SERVICE BULLETIN

FUSELAGE - TAIL BOOM

Patches on the EC130 Fenestron / tail cone link

Corresponds to modification 074775

Figure 7 (Blanking of holes at the edge distance limit)

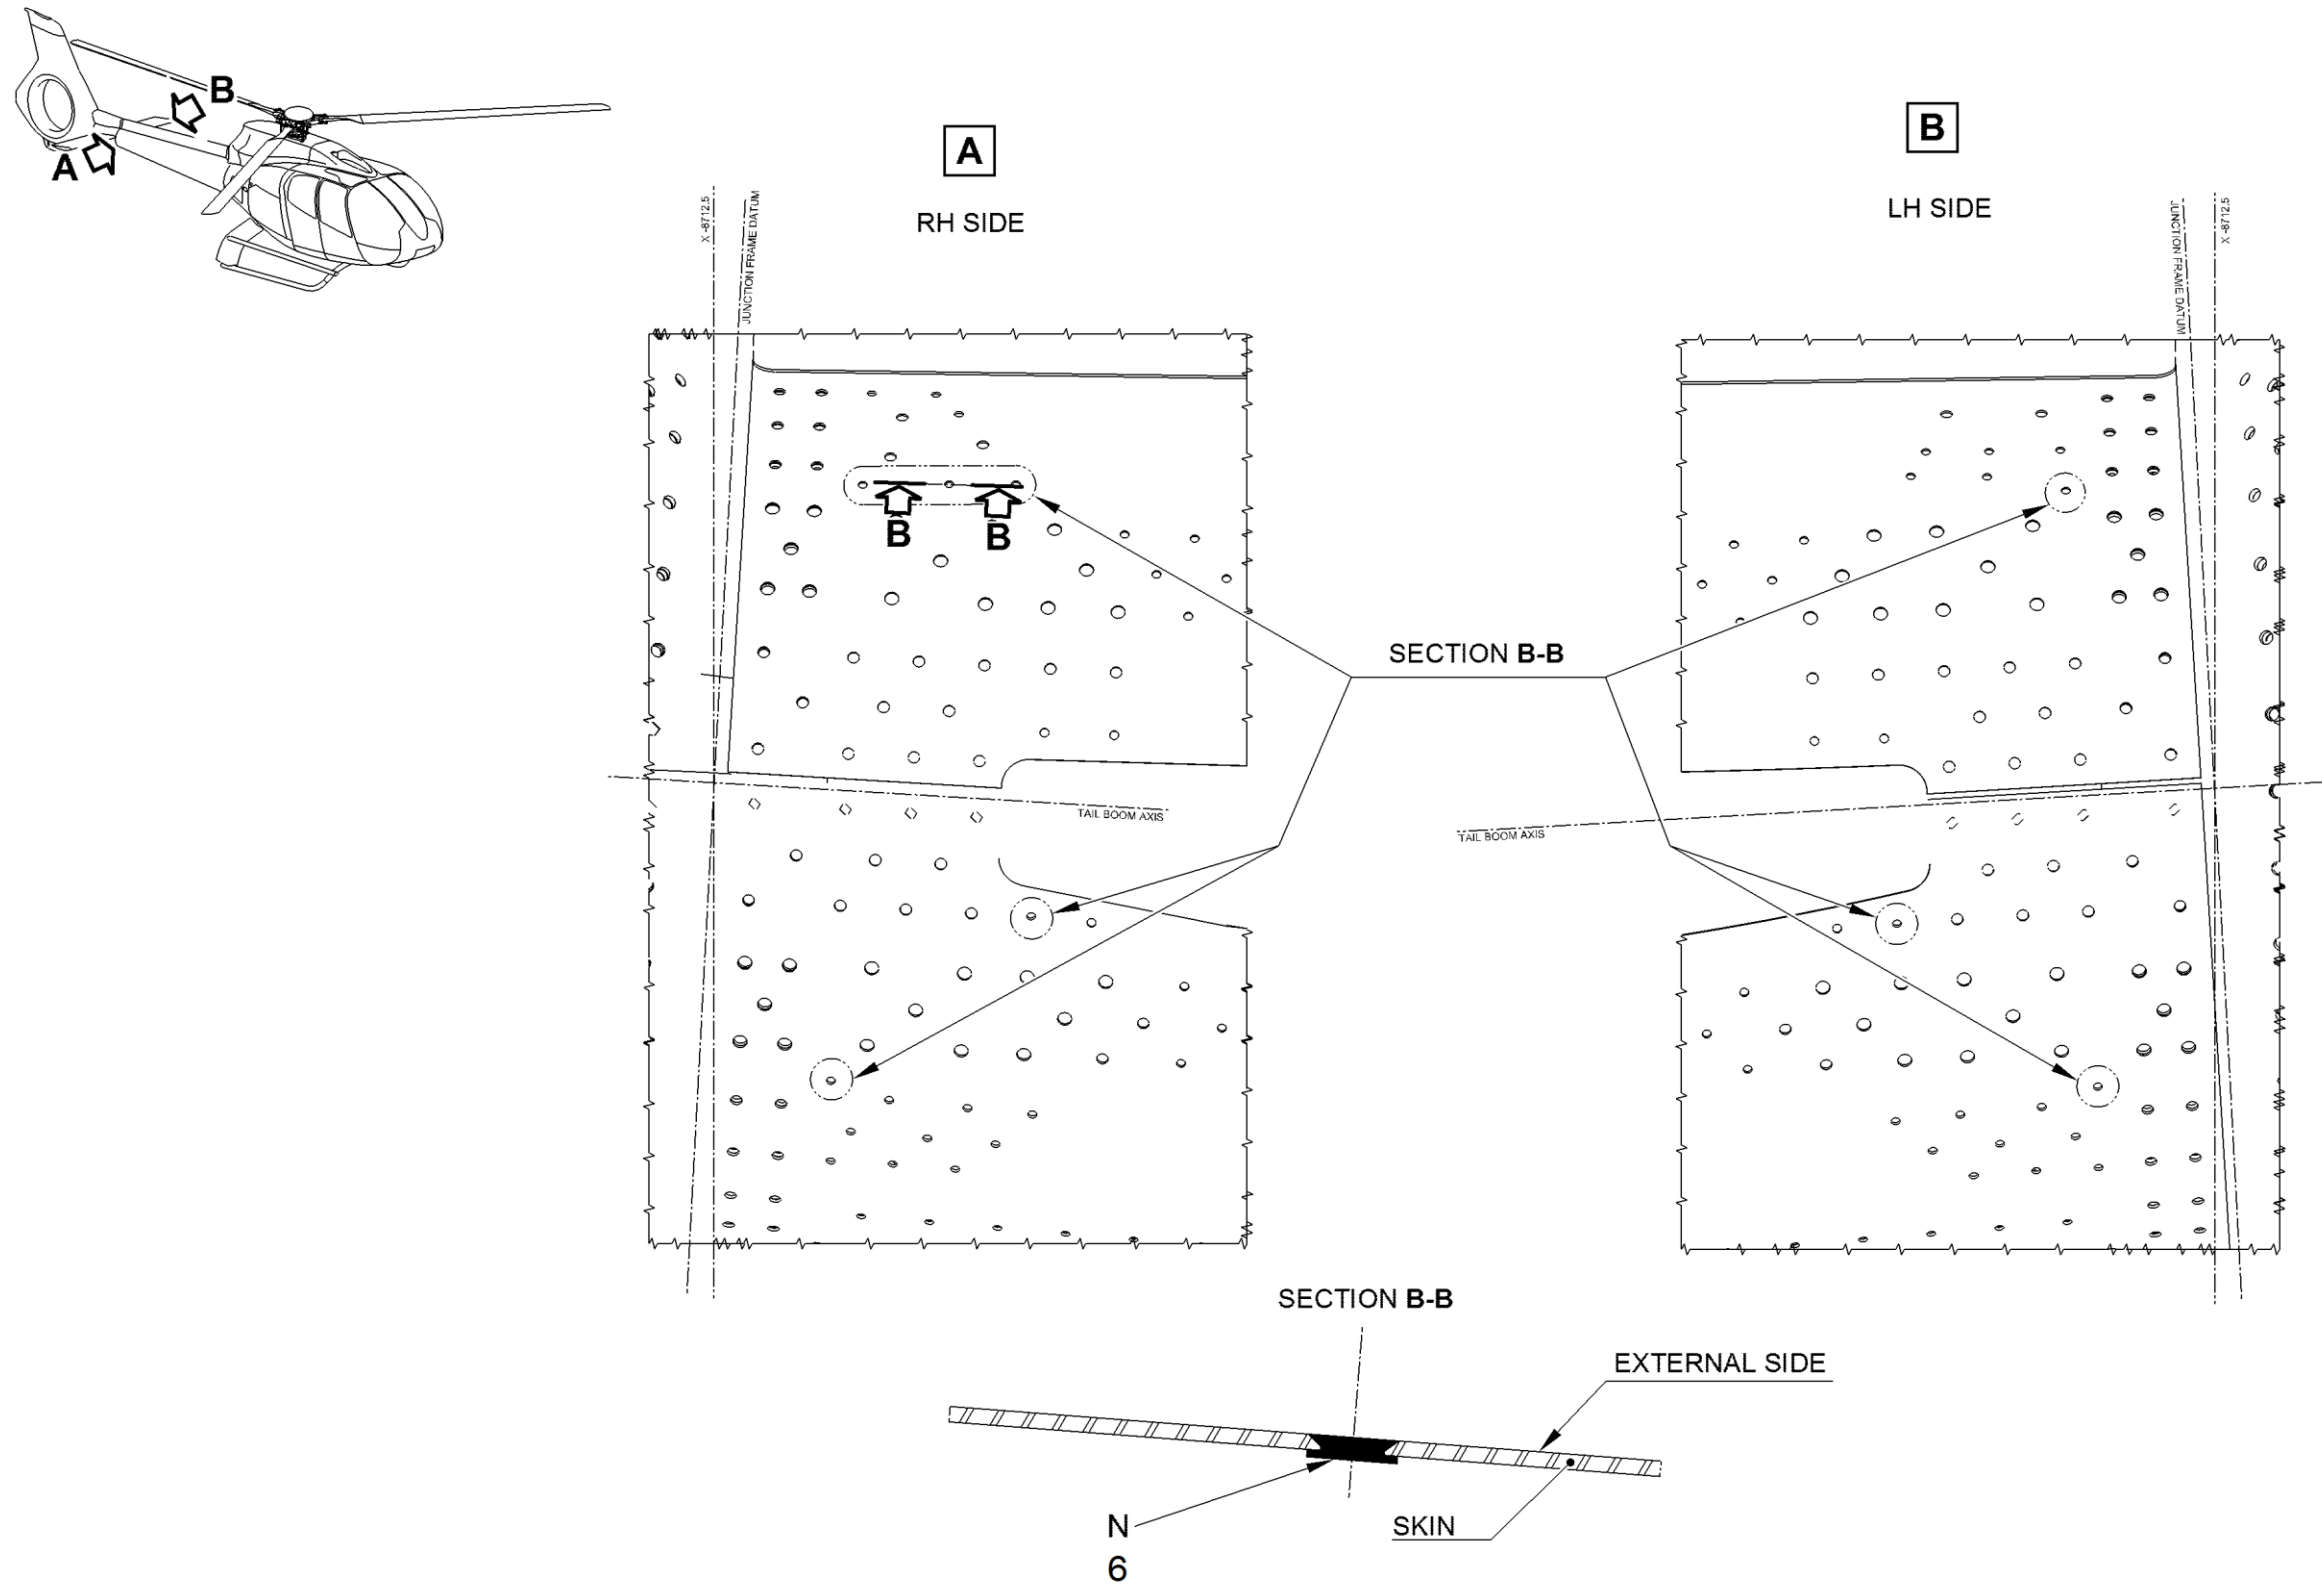
- If necessary:
 - . Blank holes N with rivets (6) as per [Figure 7](#) - Detail A and SECTION B-B.
 - . Drill holes O to diameter 4 with drill \varnothing 4 (pp) as per dimensions of [Figure 8](#) - Detail B.
- If necessary:
 - . Remove existing rivets (j) ([Figure 13](#)).
 - . Apply sealant (41) to rivets (47).
 - . Install rivets (47) instead of rivets (j).
- Drill the holes in the structure to match patch (1) as per [Figures 8](#) and [11](#).

Figure 8 (Installation of RH patch rivets)

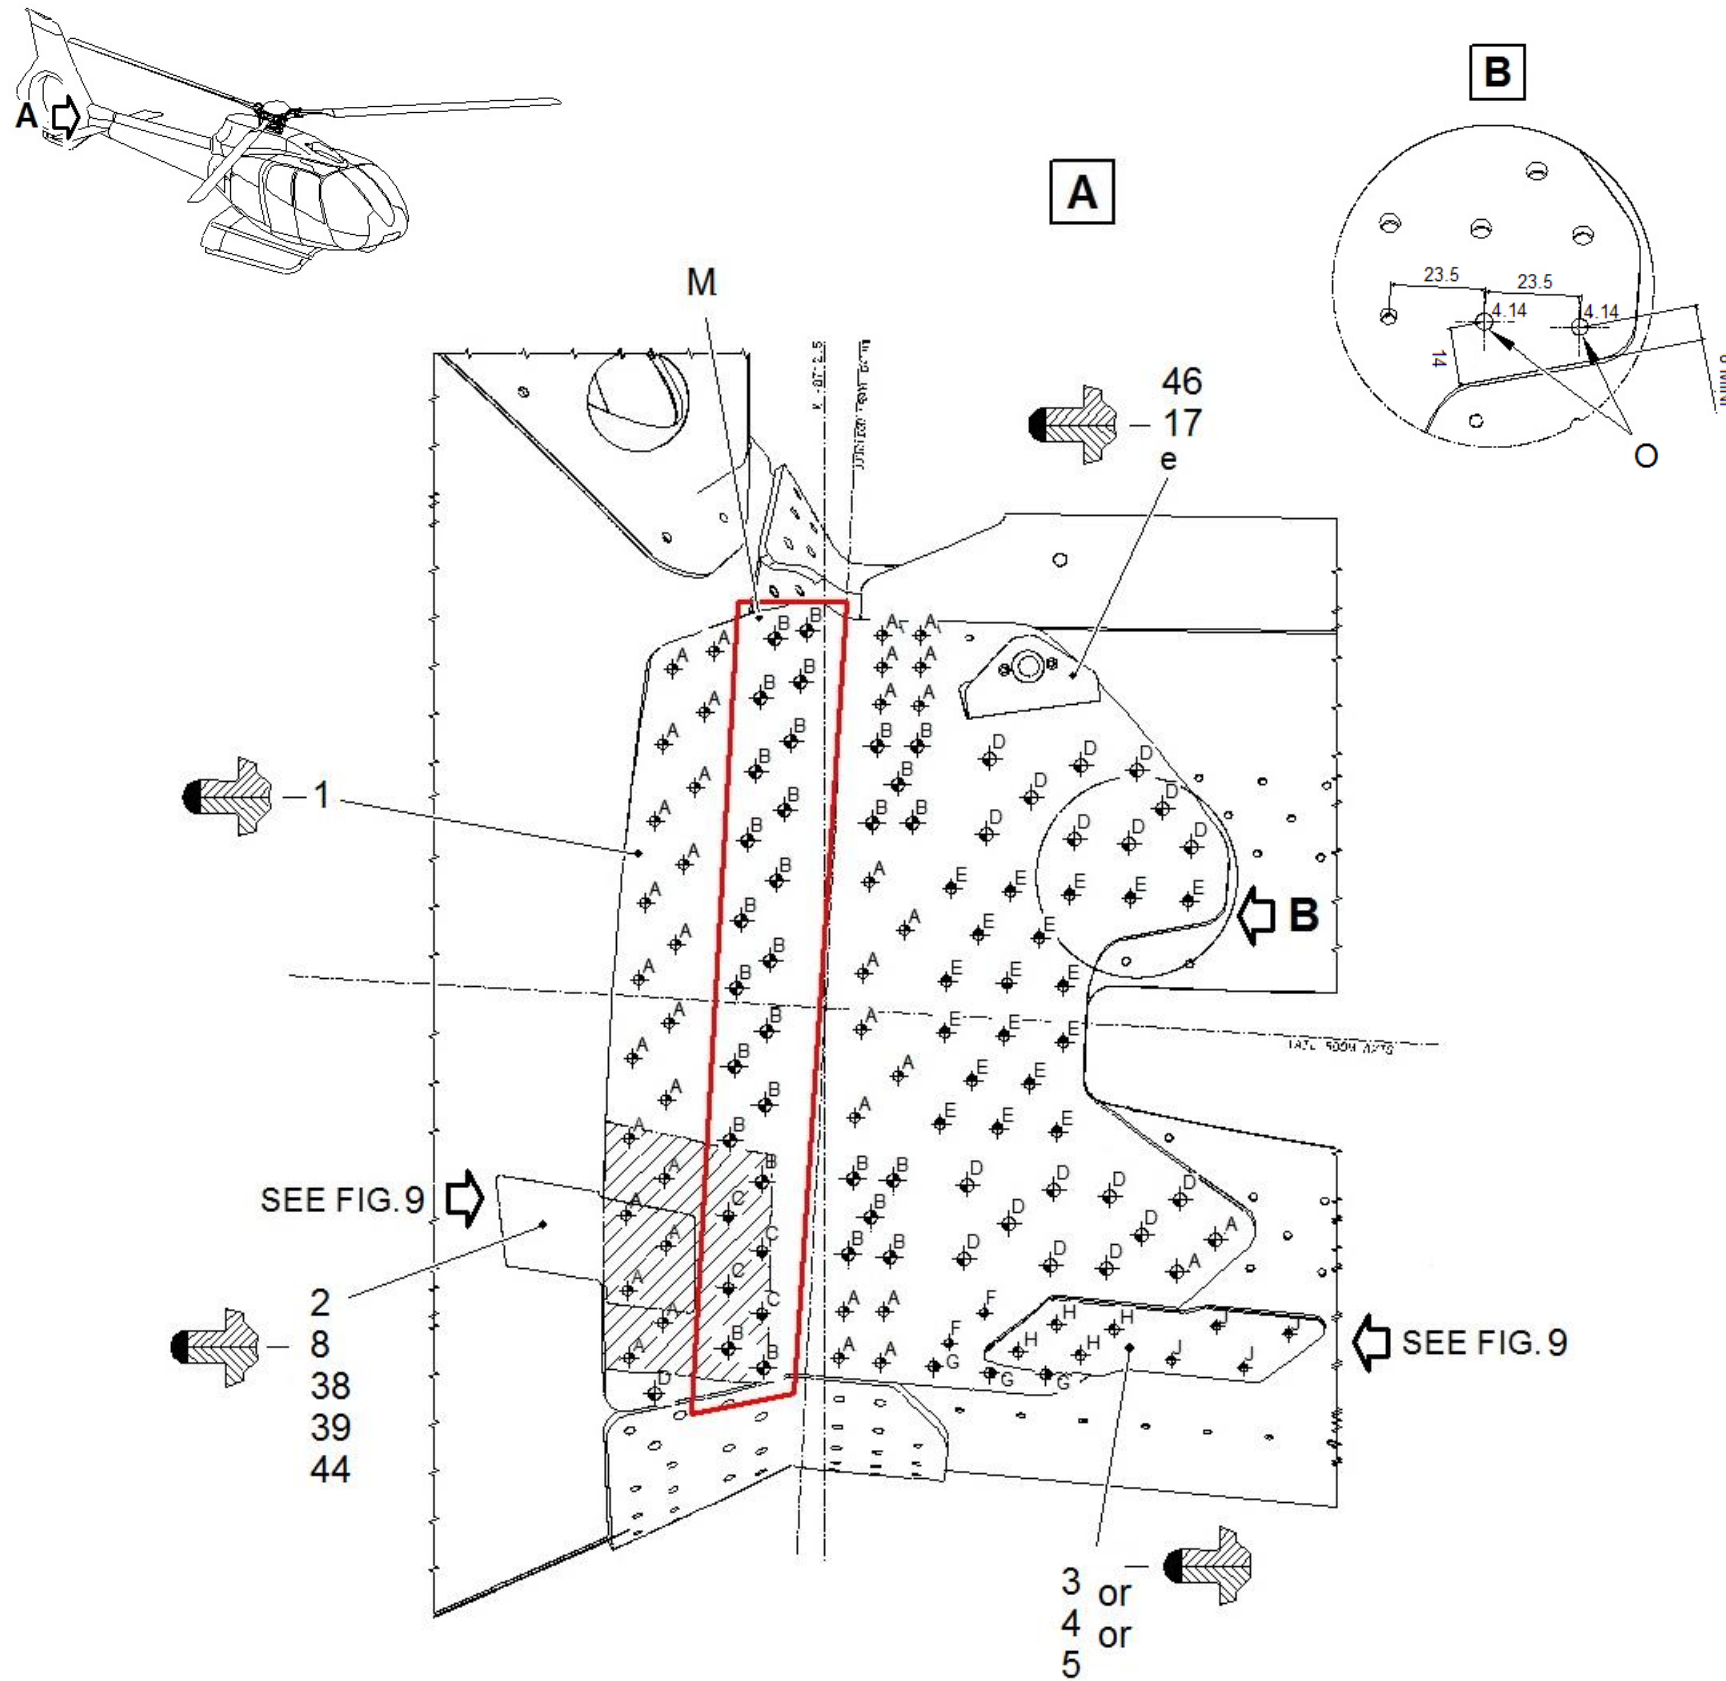
- Do not drill to the final diameter at this stage.
- On a work bench, predrill patch (1) with set of drilling bushes (ii) and drills \varnothing 3.1 (yy) or \varnothing 4 (xx) or \varnothing 4.8 (ww) as per [Figure 8](#) and [Figure 11](#).

If during removal of rivets, the existing holes are \varnothing 4 (countersunk) or \varnothing 4.8 or \varnothing 5, drill back the holes to \varnothing 6.5 as per area M of [Figure 8](#).

- Clean the area.
- Check the clearances and install shims as per [Appendices 4.D.](#) and [4.E.](#)
- Remove spring fasteners (kk).
- Drill liquid shim (37) and bore patch (1) as per [Figure 8](#) and [Figure 11](#).
- Coat the rivets with sealant (41).

For the Ø 6.5 back-drilled holes, drill liquid shim (37) and bore with drills (rr) and (ss) and install rivets (26) or (27) or (28) or (29) or (30) or (31) as per the thickness to be tightened (Area M - Figure 8).

Figure 9 (Electrical bonding rework)

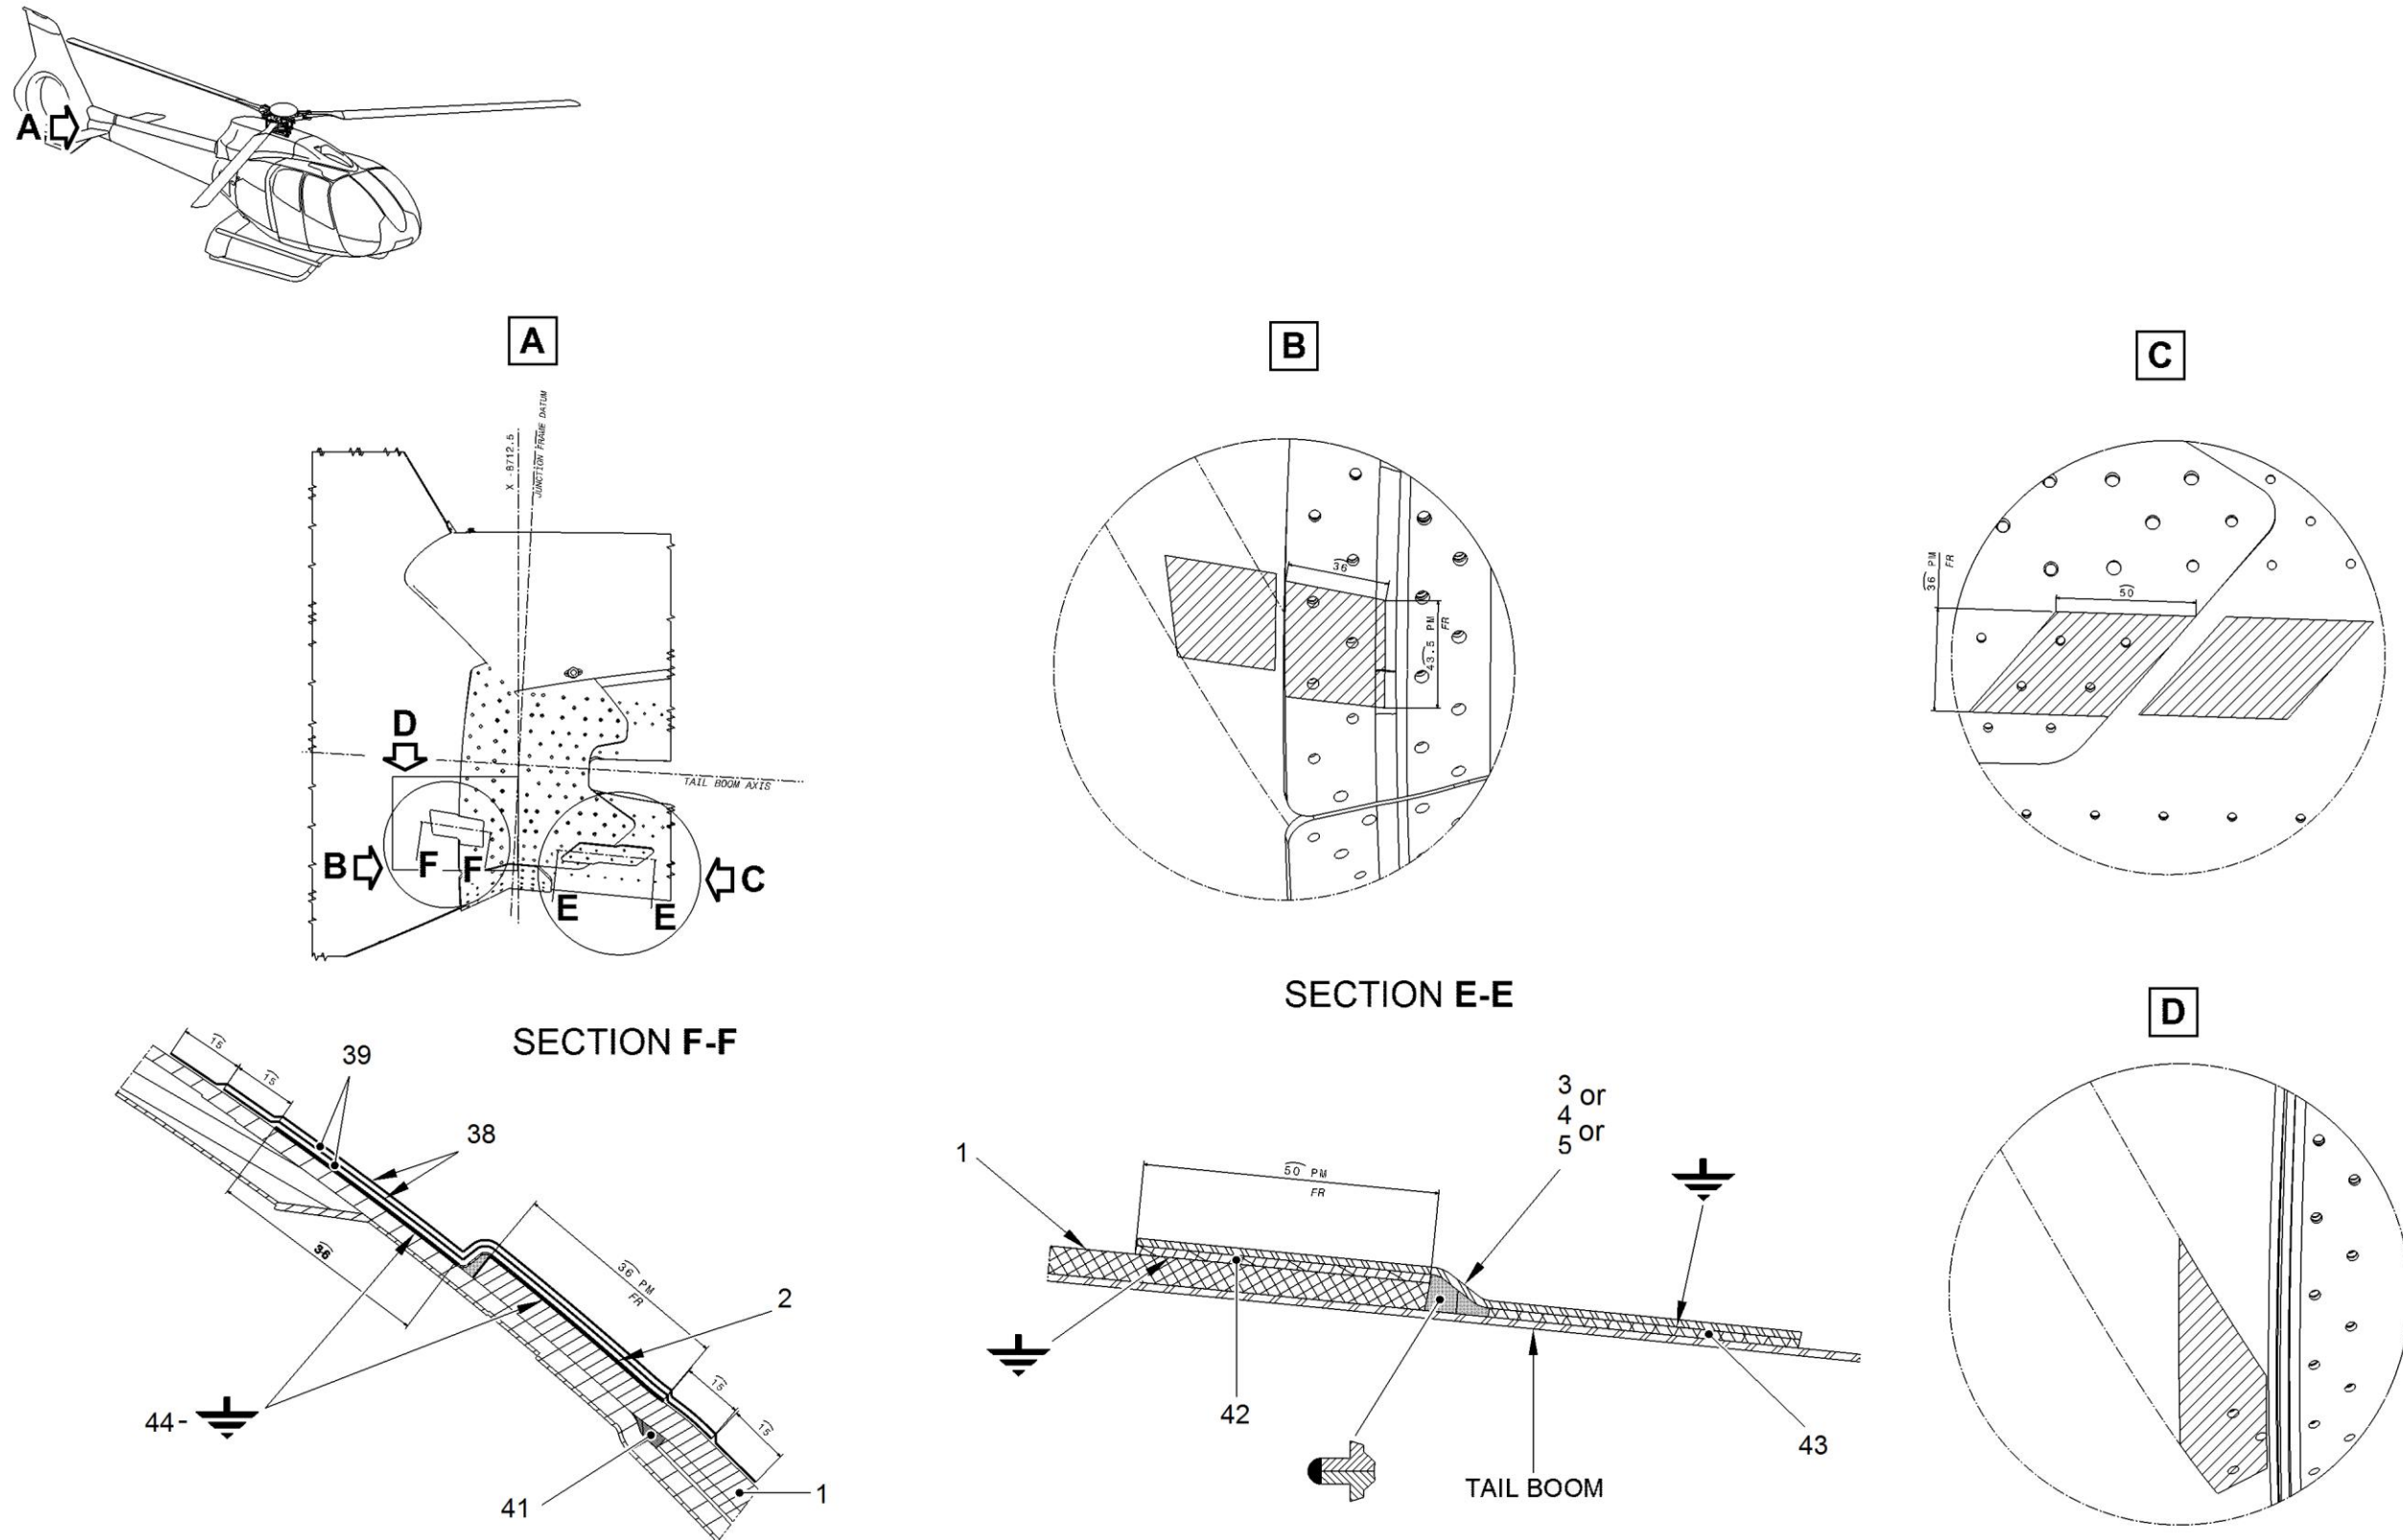
- Position and mark foil (2) and splices (3) or (4) or (5) as per [Figure 8](#) and [Figure 9](#).
- Sand the hatched area of foil (2) until the copper strip on patch (1) appears as per Figure 8 and Figure 9 - Detail B.

- Sand the hatched area of splice (3) or (4) or (5) until the copper strip on patch (1) appears as per Figure 9 - Detail C.
- Ensure electrical bonding of foil (2).

- Sand the surface of splice (3) or (4) or (5) in contact with patch (1) and the structure.
- Apply Alodine (7) to splice (3) or (4) or (5).
- Apply seals (42) and (43) to splice (3) or (4) or (5) as per Figure 9 - SECTION E-E.
